LiDAR Quality Assurance (QA) Report
San Francisco Bay LiDAR Project
NOAA Coastal Services Center
April 21, 2011

1 Executive Summary

The following LiDAR quality assurance report documents Dewberry's 3rd review of LiDAR data and derived products for the San Francisco Bay LiDAR Project. The data was flown by Fugro EarthData, Inc (FEDI) for the NOAA Coastal Services Center. The delivery of the data includes portions of seven California counties: Alameda, Contra Costa, Marin, Napa, San Francisco, Solano, and Sonoma.

Figure 27 - DTM model colored by elevation of tile C5610_42270 showing a flight line ridge that is ~18 cm. The profile and distance units are in meters. This flight line ridge is temporal and there is no issue.

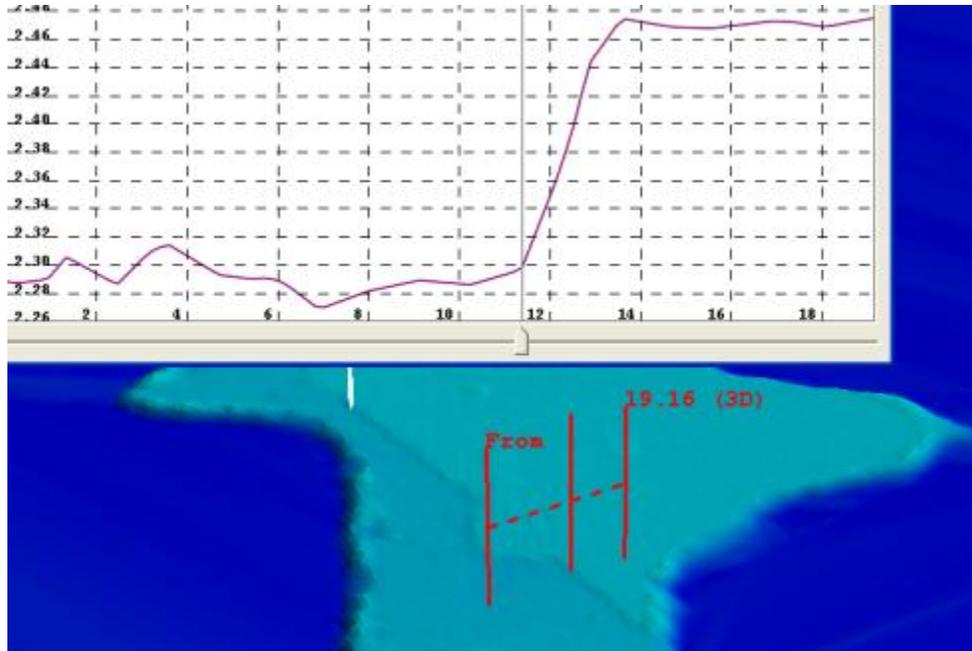
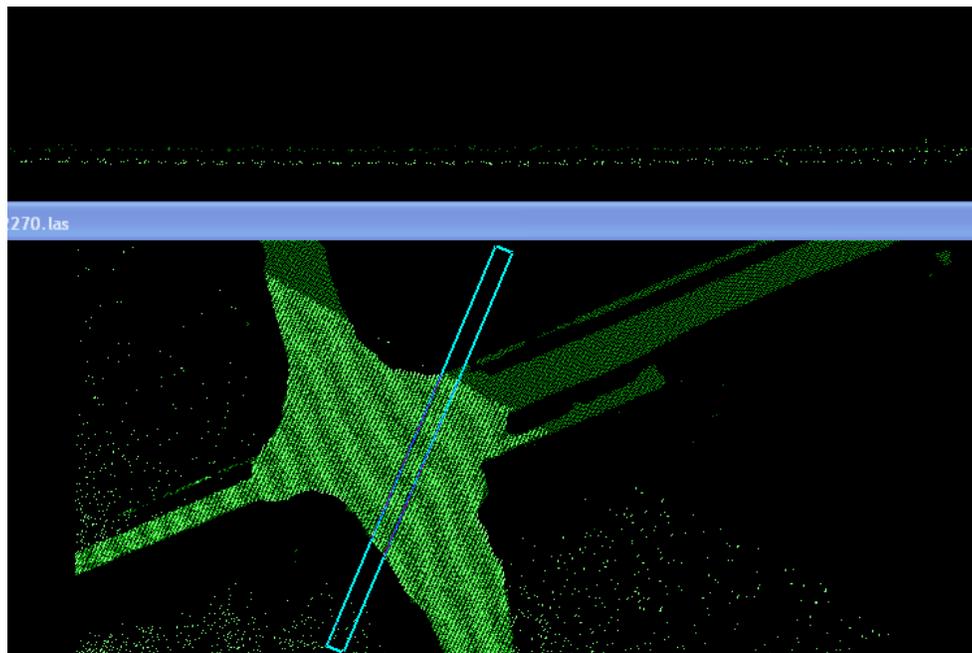
Call_FEDI_REPLY_041411.doc provided to Dewberry by FEDI on April 14th, 2011, the flight line ridge in question is due to a temporal change in the surface (Figure 27 and Figure 28).

Figure 28 - Image from Fugro Viewer of tile C5610_42270 showing, on the top half, a profile of the points colored by flight line source ID and, on the bottom half, a map view of the points colored by flight line source ID. As visible in profile view the two flight lines are offset from each other by ~18 cm (distance measured in the program).

Again, this flight line ridge is temporal and is shown here to make the end-client aware of the issue.

Figure 29 - Ground density model of Tile C5355_42300 that shows two areas of voids that are in class 1 (unclassified). It appears that the intensity image reveals that there is ground in these two areas and is therefore misclassified. The image below shows this issue is fixed in the 2nd delivery.

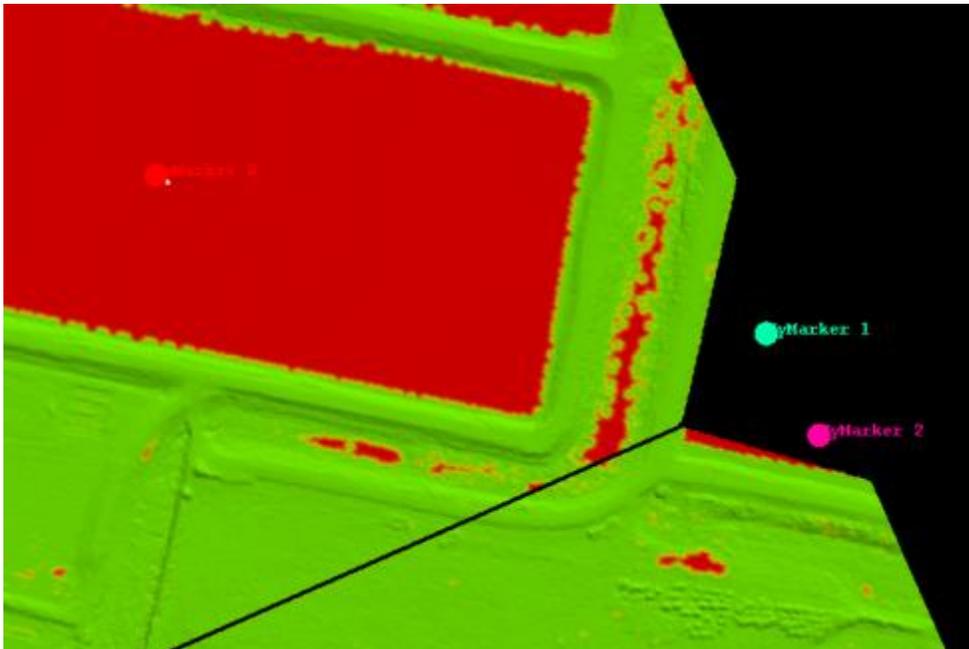
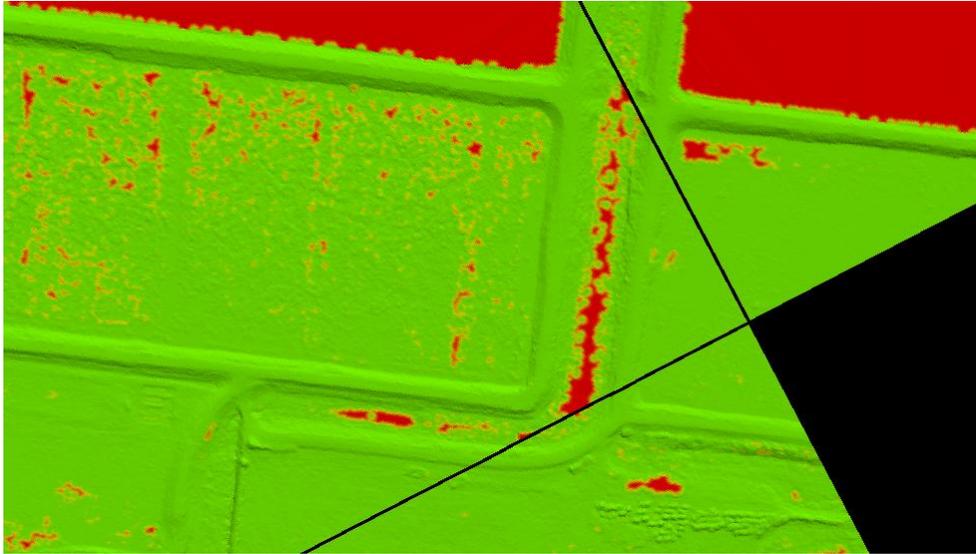
Misclassification issues occur when points are not correctly classified. Misclassification of points constitutes a small portion of the data. The majority of points that are misclassified are either: 1. Ground points that are in water or on buildings, 2. unclassified points that should be ground or 3. Points classified as water that should be ground/unclassified. All the misclassification calls are addressed by FEDI in the 2nd delivery. Images below show examples of how the calls were fixed.

Figure 30 - Ground density model of Tile C5355_42300 that shows the two areas of misclassifications that have been fixed in the 2nd delivery.

Figure 33 - Full point cloud DTM model colored by elevation of tile C5445_42165 showing the elevation spikes along nadir.

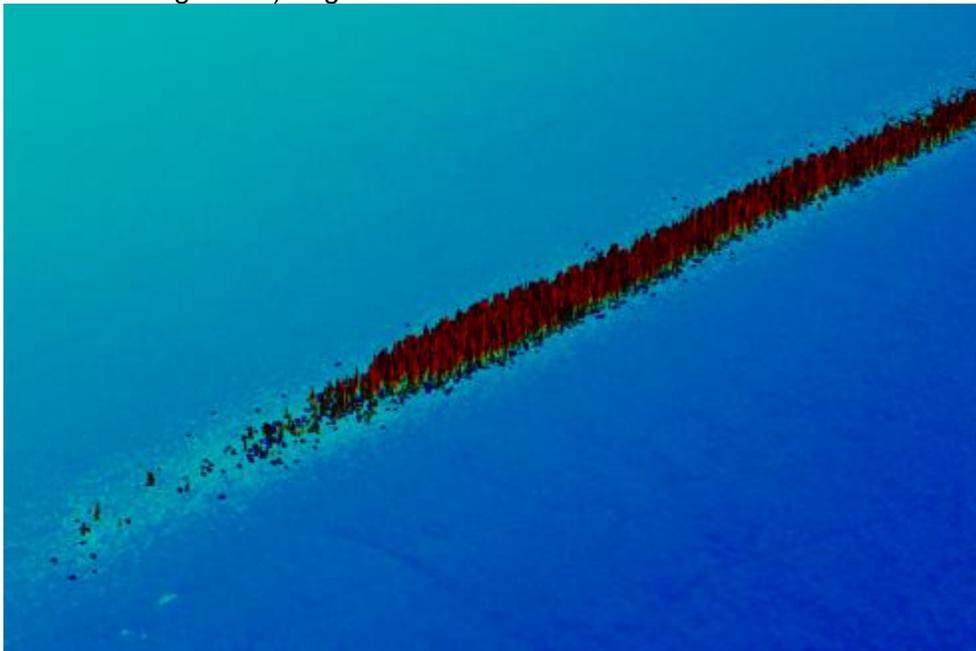
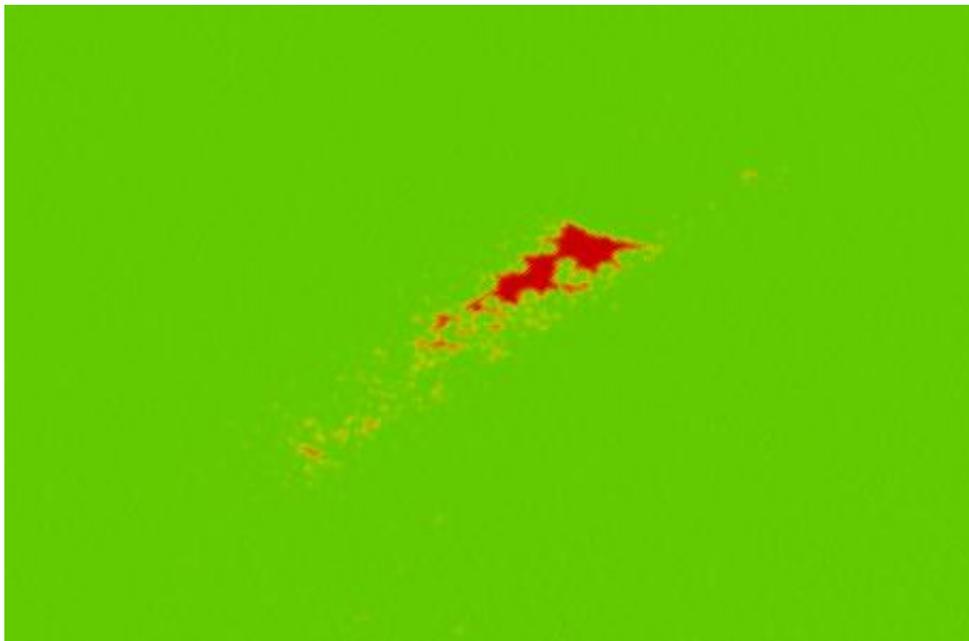
The intensity image in tile C5445_42165 reveals high intensity values at nadir which will sometimes cause what look like elevation spikes in the full point cloud. The “nadir spike” streak is caused by anomalous readings from the LiDAR sensor. There are two images showing the issue from previous deliveries (Figure 33 and Figure 34). Figure 35 shows that the issue is addressed in the 3rd delivery.

Figure 35 – Ground density model showing that the artificially high ground points are removed from the ground model.

Figure 37 - Full point cloud intensity image of tiles c5520_41790 & c5520_41805. The blue dots are LiDAR points classified to water. There are no hydrographic breaklines in this area.

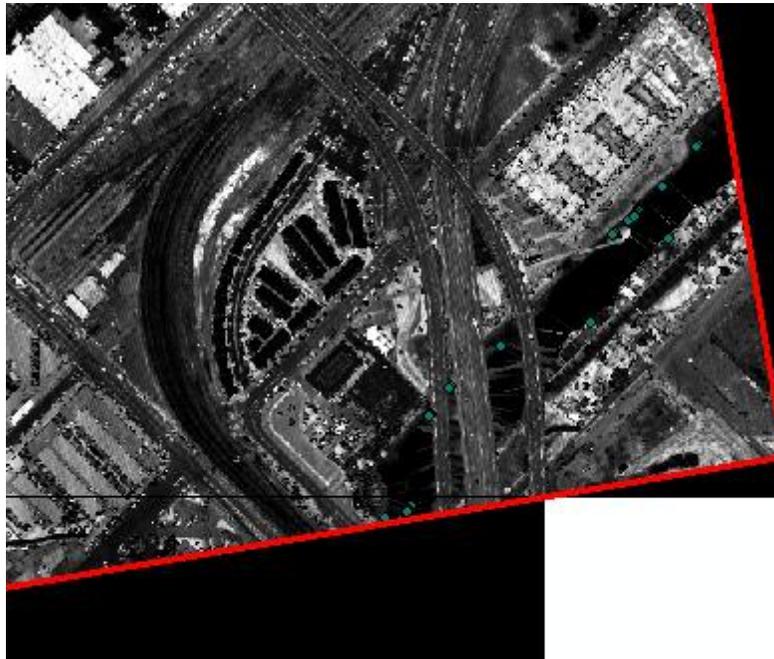
In the 2nd delivery, Dewberry noticed that tiles c5520_41790 and c5520_41805 have points classified as water, but there are no breaklines covering those points. Dewberry recommends adding breaklines in this location to match the classification of points for consistency. An image is provided below in Figure 37

In the 3rd delivery, FEDI delivered a revised set of breaklines where this feature is correctly outlined and therefore this issue no longer remains.

Figure 38 - Full point intensity image of tile C5520_41835 showing that piers are not removed by the tidal waters breakline (the blue line). These features should be removed because it can reasonably be determined where the edge of the water most probably falls beneath the piers.

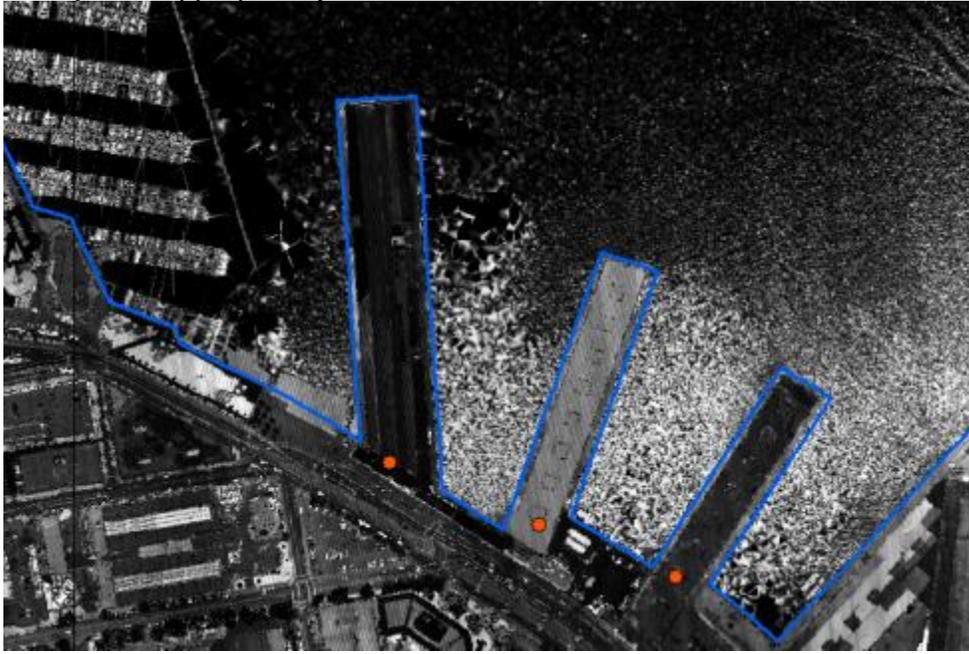
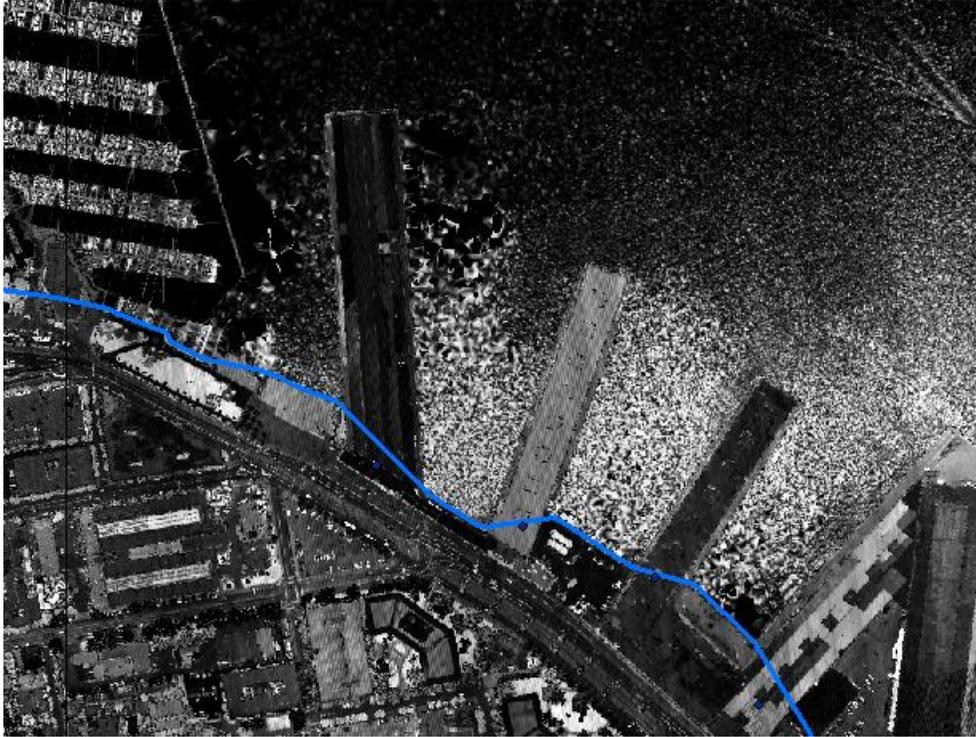
In addition, during the initial QA, Dewberry identified numerous piers around San Francisco Bay that were not removed from the ground model. Dewberry suggested these be removed from the ground model as it could reasonably be determined where the edge of the water most probably falls beneath the piers. These piers are now removed from the dataset in the 3rd delivery and the breaklines and LAS classification are adjusted appropriately.

Figure 39 - Full point cloud intensity of tile C5520_41835 from 3rd delivery. The breaklines are adjusted and the piers removed from the ground model.

Figure 40 - Full point cloud intensity image of tile C5745_42090 showing that an inlet is not captured by the tidal waters breakline (the aqua-blue line) as well as inaccurate placement to the north. This image is from the 1st delivery and is corrected in the 2nd delivery as shown below.

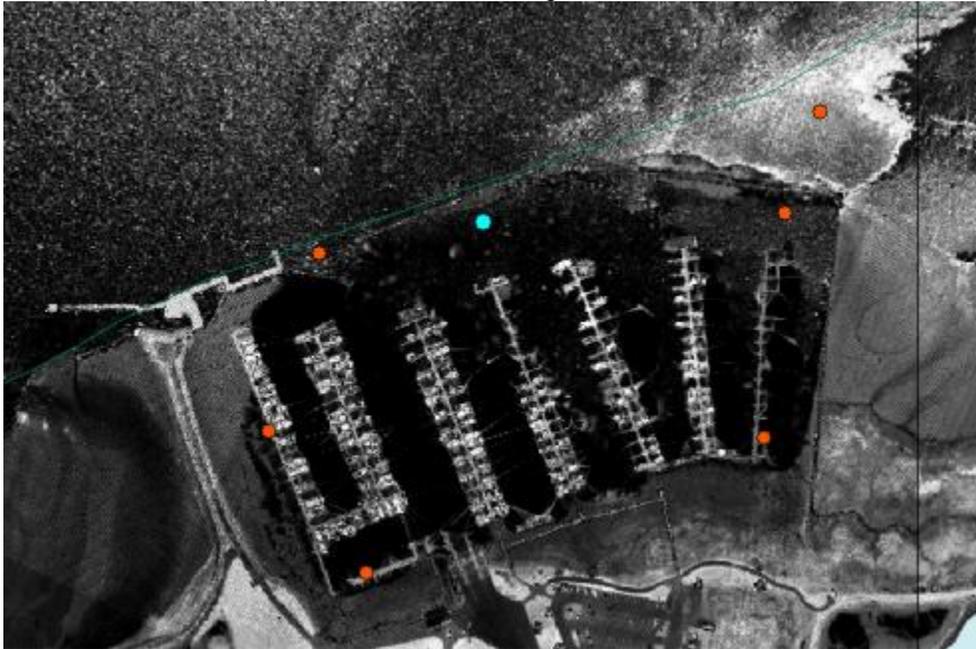
In the initial review of the database, Dewberry identified several areas where the breaklines are too general, several inlets that were not incorporated into the tidal water breaklines, and some inaccurately captured breaklines. FEDI addressed all calls that Dewberry made. Some examples are provided below to show fixes that were made (Figure 40 and Figure 41).

Figure 41 - Full point cloud intensity image of tile C5745_42090 showing that in the 2nd delivery all the calls are addressed and correctly fixed.

Figure 42 - Full point cloud intensity image of tile C5490_42315 that shows a water body feature that is over 2 acres in size that is not captured by the Lakes and Ponds feature class in the 1st delivery. This issue is resolved in the 2nd delivery as shown below.

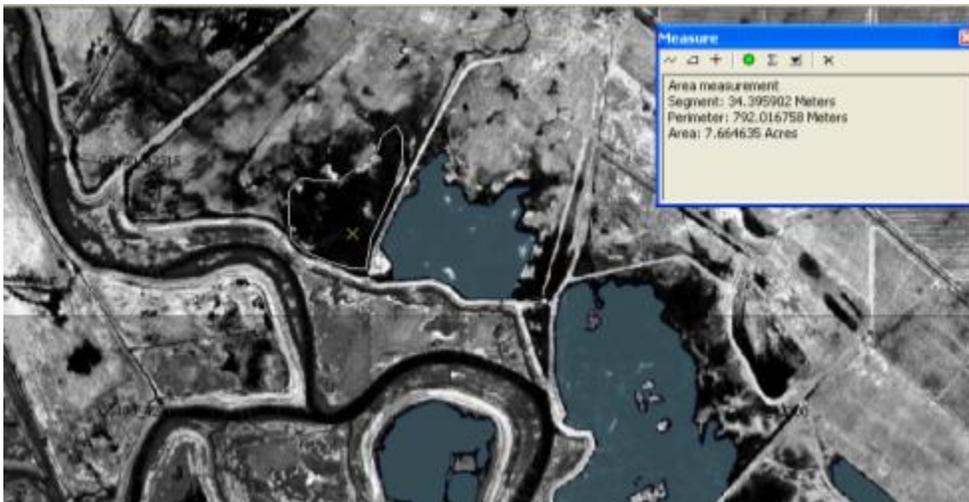
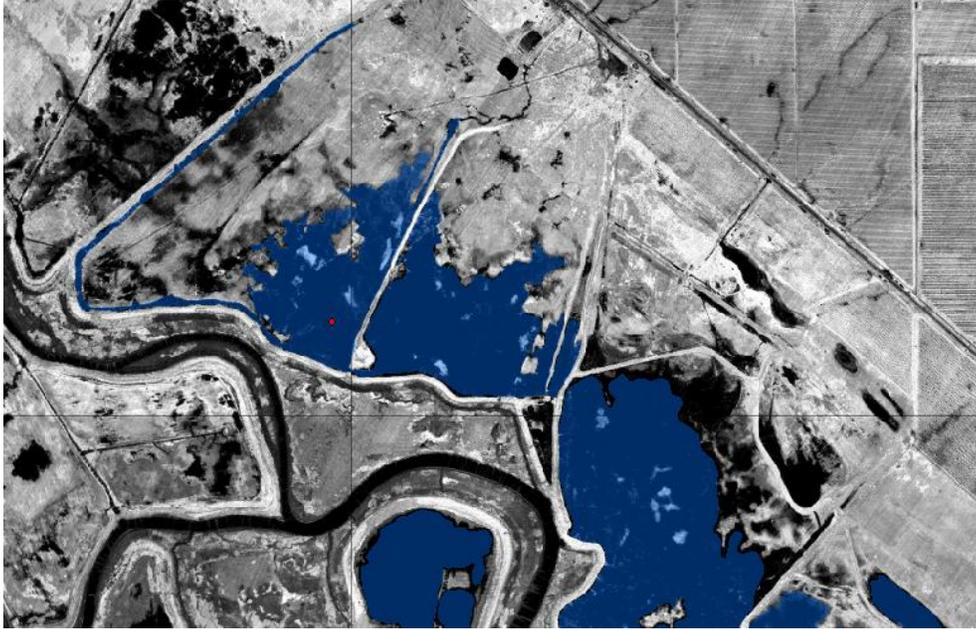
In the initial QC of the 1st delivery, Dewberry identified numerous features that were not captured. FEDI has addressed all calls during the 3rd delivery and collected all missing features if they met collection specifications. An example is provided below in Figure 42 and Figure 43.

Figure 43 - Full point cloud intensity image of tile C5490_42315 that shows the water body is captured in the 2nd delivery.

Figure 44 - Full point cloud intensity image of numerous tiles (identified in picture) that show numerous small islands captured and extracted out of the tidal waters polygon in the 1st delivery. This issue is addressed in the 2nd delivery as shown below.

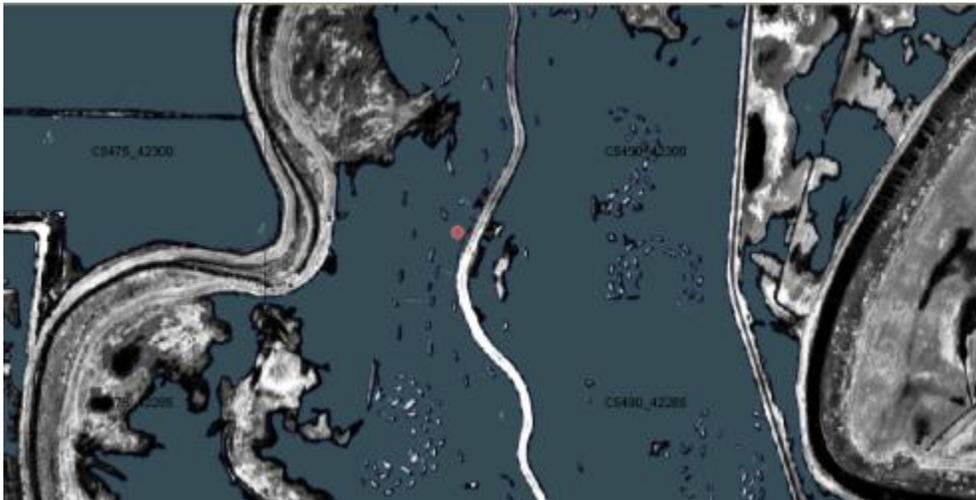
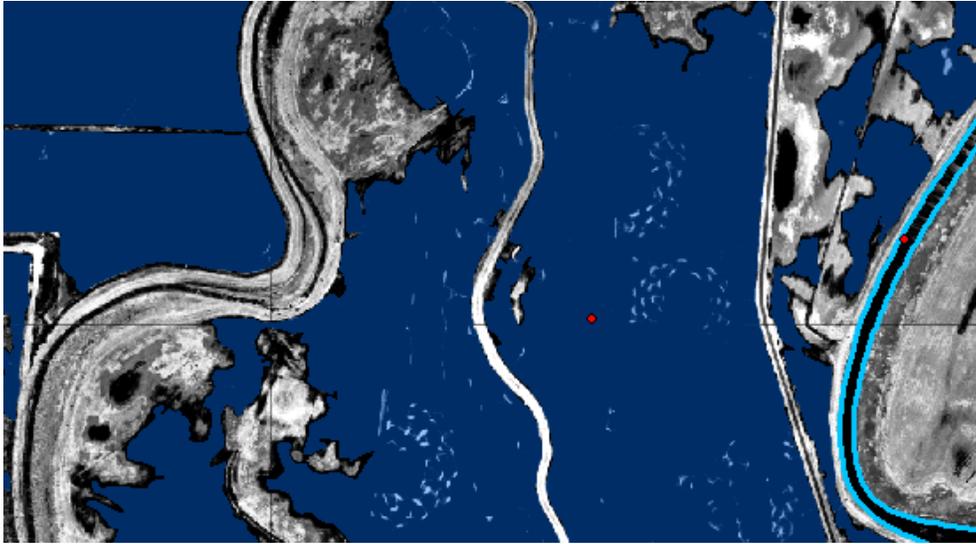
In the initial QC of the data, Dewberry identified that islands are captured inconsistently throughout the dataset. FEDI removed the small islands (<0.5 acres) from the breaklines and captured islands that Dewberry called out. No further issues were identified and examples are provided below of FEDI's corrections (Figure 44 to Figure 47).

Figure 45 – Full point cloud intensity image of numerous tiles (identified in picture above) showing that the island are removed in the 2nd delivery.

Figure 47 – Ground density model of tile C5505_41865. Alcatraz island is now incorporated into the ground.

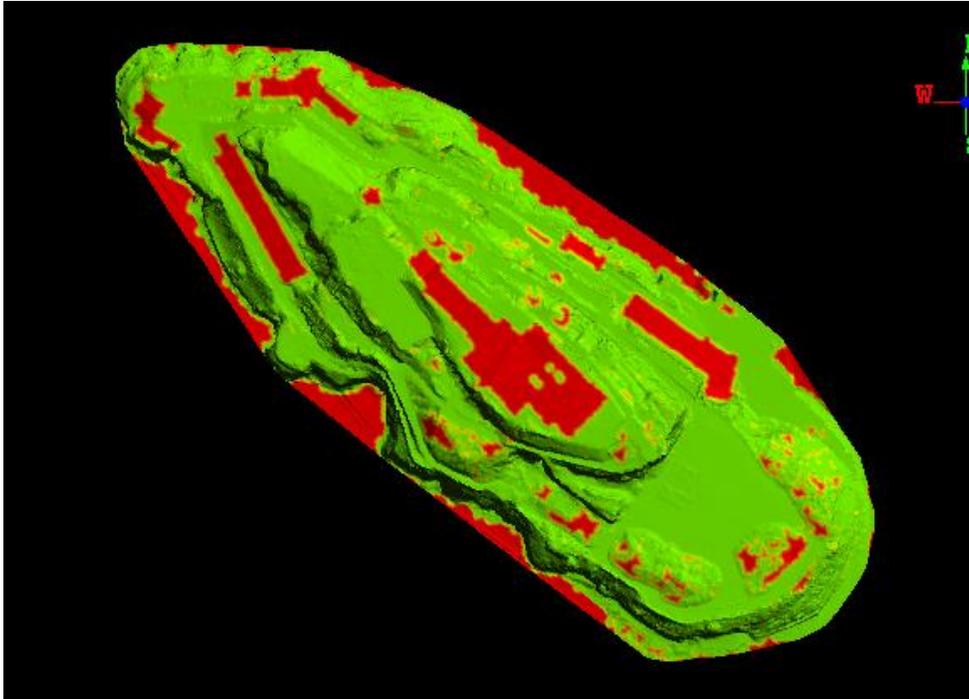
Figure 46 - Full point cloud intensity image of tile C5505_41865. In the 1st delivery this was not captured by the breaklines and did not appear in the ground model. This is fixed in the 2nd delivery as shown below.
